APPENDIX 6 – HIGHWAYS, TRANSPORT & DESIGN COMMENTS
Application 16/3035/OUT

INTERNAL MEMORANDUM
 Highways, Transport and Design

Proposal: Outline application with for the erection of up to 90 dwellings and associated access (all other matters reserved).	Date:	04/07/17		
Location: Land West Of St Martins Way, Kirklevington	Ref:	16/3035/OUT	Rev	4

Plan 2 - Site Access Arrangements

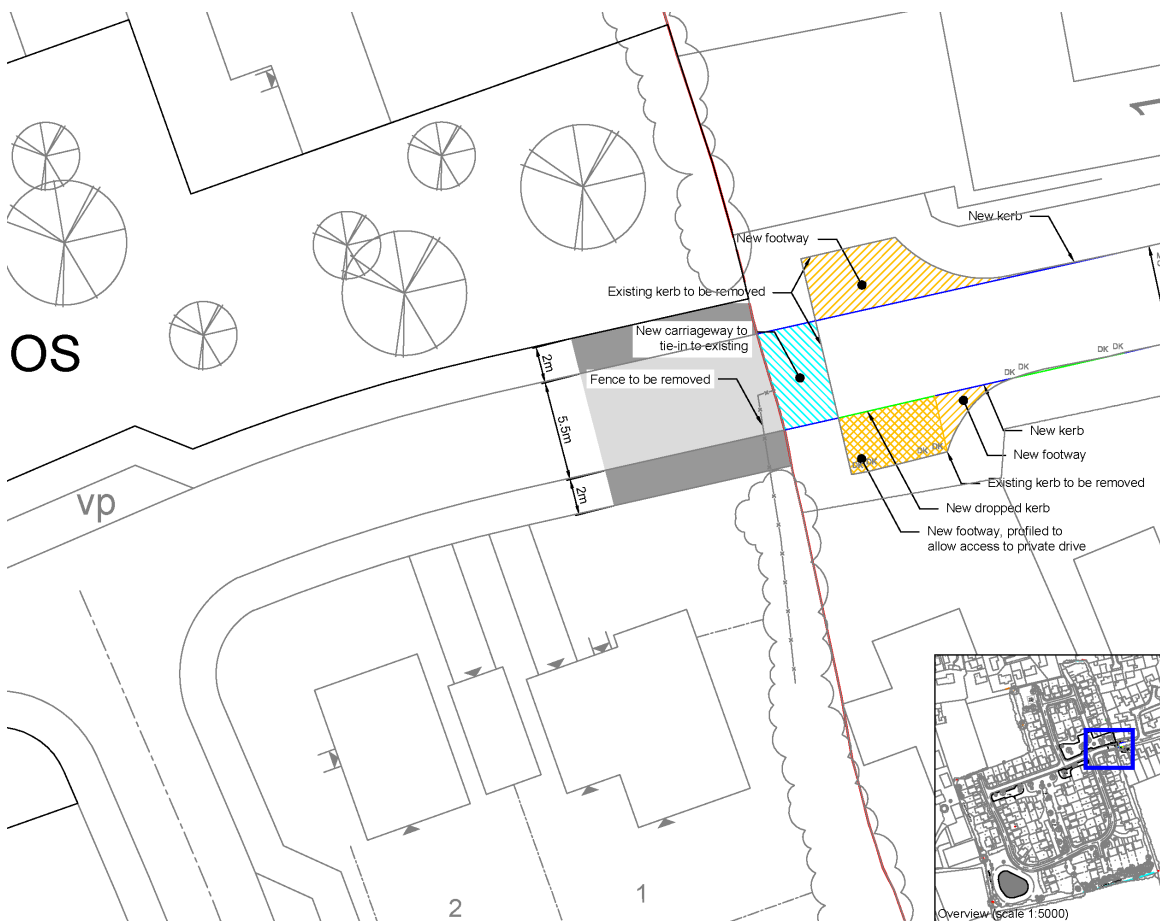
The site will be accessed from St Martins Way, which is accessed from Forest Lane via The Green or Strathmore Drive. The development road would be constructed to adoptable standards and would form an extension of St Martins Way. Details of the proposed site access arrangements are shown on Drawing HJB/PA3864/15a and would provide a 5.5m carriageway with 2 m footways either side taken from the cul-de-sac at the head of St Martins Way as shown below on Plan 2. As a part of the site access arrangements the existing turning head will be removed and areas reinstated to verge, the footways would also re-aligned to provide a direct connection to the proposed development.

The drawing indicating the site access arrangements are considered to be acceptable.
